R190710_118116_75CarltonCrescent_SiteFloodAssessment_Final

74-75 Carlton Crescent, Flood Impact Assessment

74-75 Carlton Crescent Summer Hill DA Flood Condition Response

Inner West Council DA Response

A03.100 - LOWER GROUND PLAN

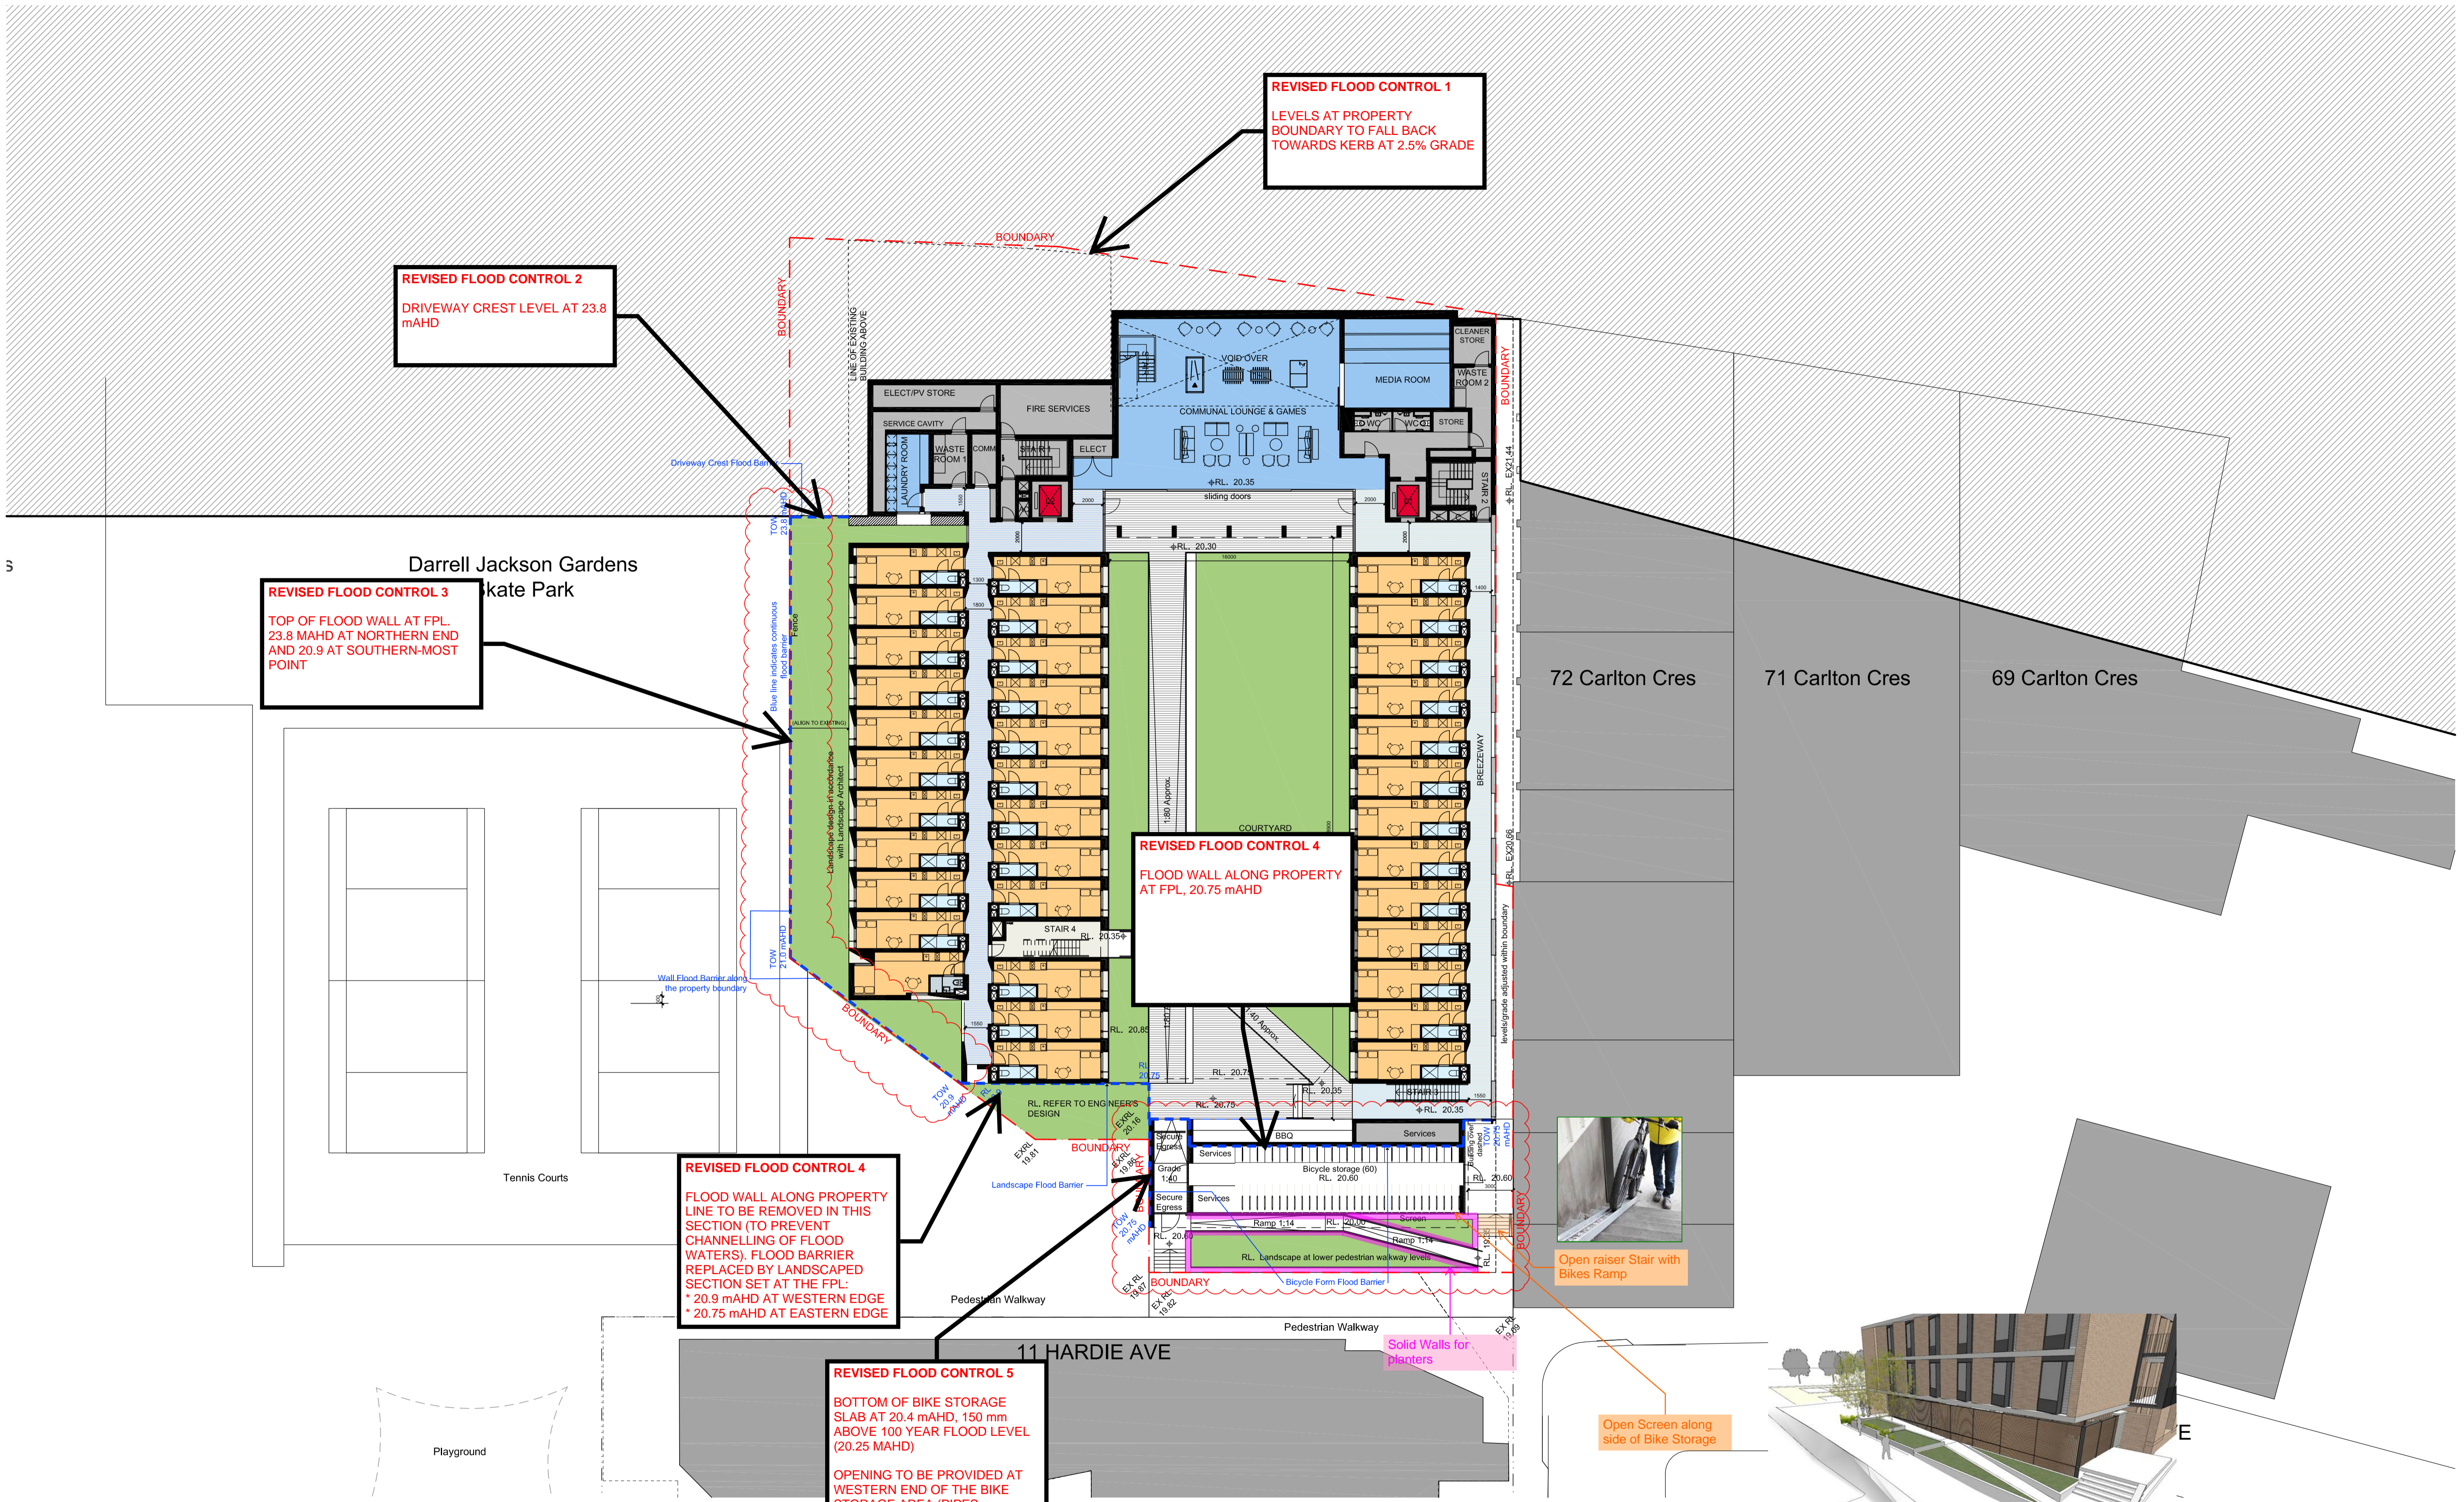
The southern extent of the north-south line of the flood wall, with the proposed height of RL 20.8m AHD is unacceptable (this height is indicated as superimposed on the Lower Ground Floor plan, Bates Smart architectural drawing Drawing A03.100, dated 7 December 2018, reproduced in Appendix B of the TTW Flood Assessment Report).

The height of the flood wall for this control shall be set as RL 23.9m AHD at the northwest of the site and RL 21.3m AHD at the southern extent on the approximate north-south line of this wall.

The flood wall shall not continue past the change in direction of the existing boundary from the section where the northwest-southeast wall alignment ends at the south of the site. Council's concern is that flood walls at the southern end of the site shall exacerbate the High Hazard flood conditions by training the flow of flood water and increasing depth. The height at the extent of the flood wall at the south of the site shall also be RL 21.3m AHD.

Given the above, Council Engineers have accepted TTW's recommendation that the height of the flood wall along the western edge of the property be set at 23.8 m AHD at the northern end, 21.0 m AHD at the southern end and 20.9 mAHD at the interface with the building (see correspondence attached as Appendix B).

Council has indicated as part of their DA response, that the proposed flood wall should not continue past the change in direction of the existing boundary (i.e. it should not continue to the horizontal). Bates Smart have provided landscaping outside of the building boundary with a crest level equivalent to the FPL as an alternative flood protection measure. TTW are of the view that the use of landscaping is an appropriate flood mitigation measure and adequately addresses Council's concerns with the channeling of flows along a proposed flood barrier. Landscaping crest levels will need to be set to the FPL of:

- 20.90 mAHD at the western edge of the landscaping area; and
- 20.75 mAHD at the eastern edge of the landscaping area.
